Addendum to Report No. NVE2506-1
Issued on 6th August 2007

A Survey of Background Noise
at 146-162 Kilburn High Road and 4-10 Kingsgate Road,
Kilburn, London NW6

Comments of Tom Brodowski on
Report No. 721022/R1/F entitled
"Robert O'Hara Architects 146 -162 Kilburn High Road
Environmental Noise Assessment"
issued in June 2005.

Table 1 - Predicted internal noise levels in the proposed residential apartments

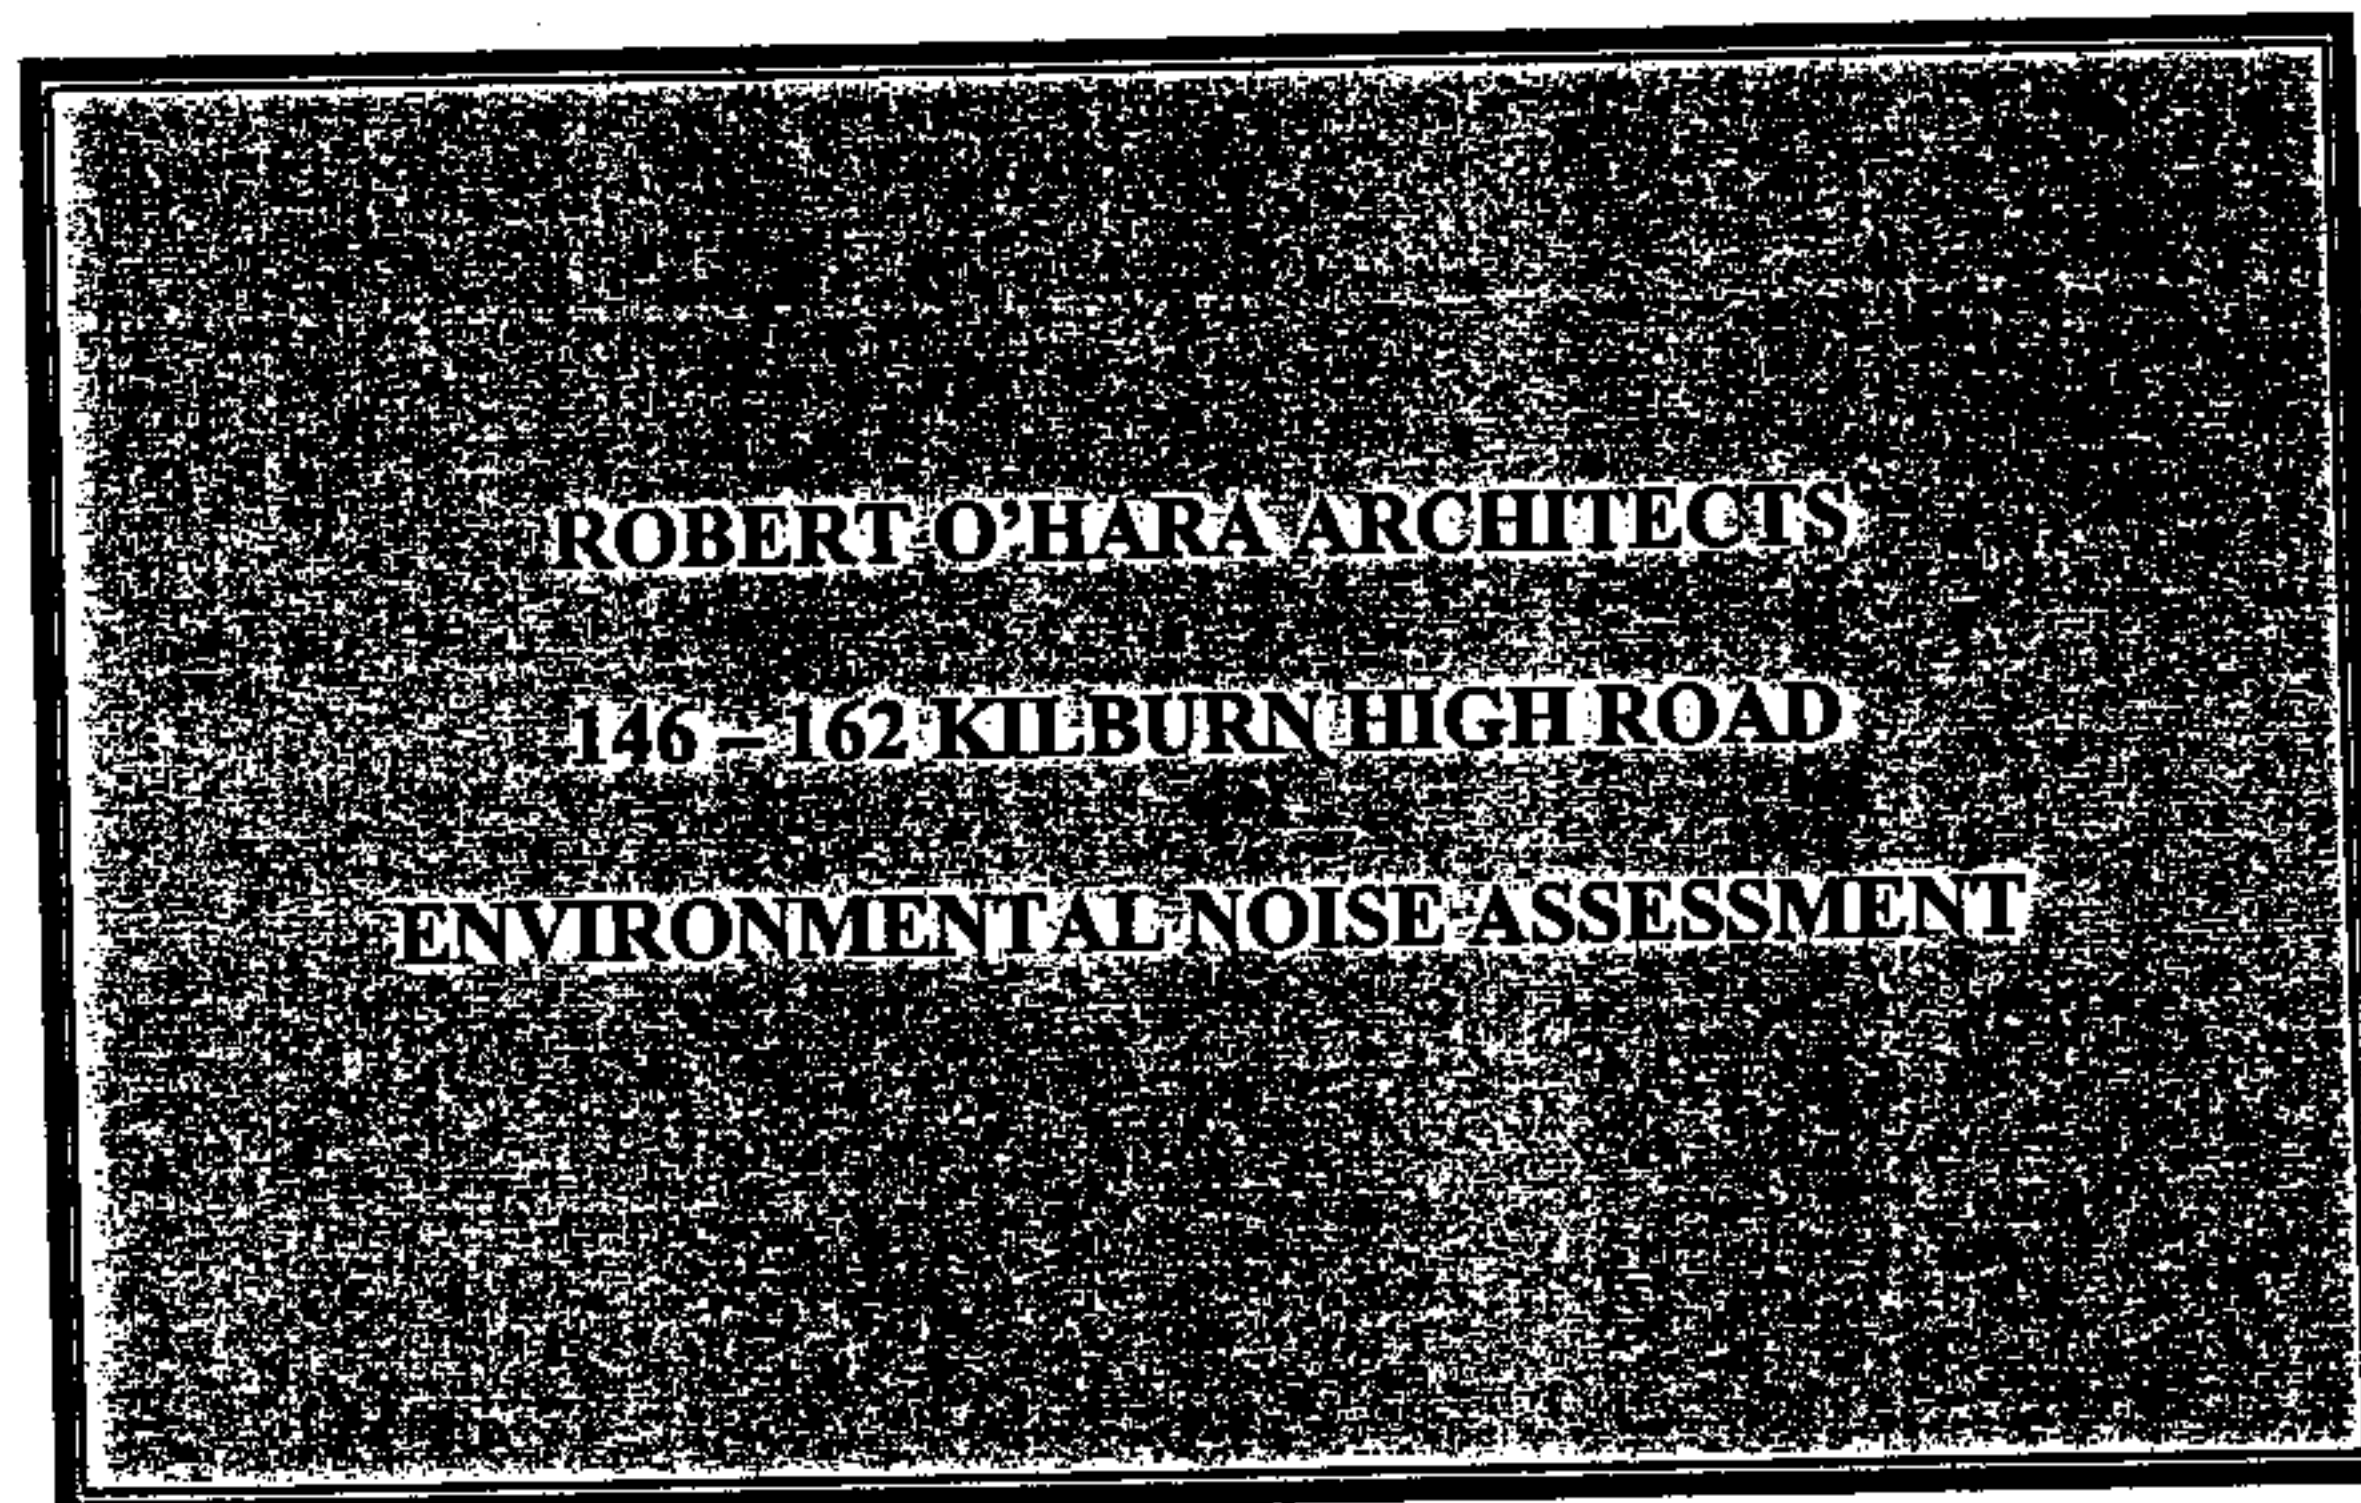
However, I believe that the design criteria on this project can be relaxed for living rooms, i.e. 40dB L_{Aeq} 0700-2300. This is compatible with reasonable resting conditions in living rooms according with Table 5 of BS8233: 1999.

Furthermore, the requirement for glazing in the 2005 report refers to facades rather than the uses of rooms, i.e. bedrooms or living rooms. This is important because the internal noise criteria for bedrooms are driven by the maximum noise levels and for living rooms should be driven by average noise levels.

Taking the above into consideration, I recommend that the glazing and ventilation shown in table 1 below be used on the latest project.

* It should be expected that levels of noise at the façade overlooking the internal courtyard should not be higher than those at the facades overlooking Kingston Place. Standard thermal double-glazed units (typically R_w 31dB) should, therefore, be more than adequate for the bedrooms and living rooms overlooking the internal courtyard.
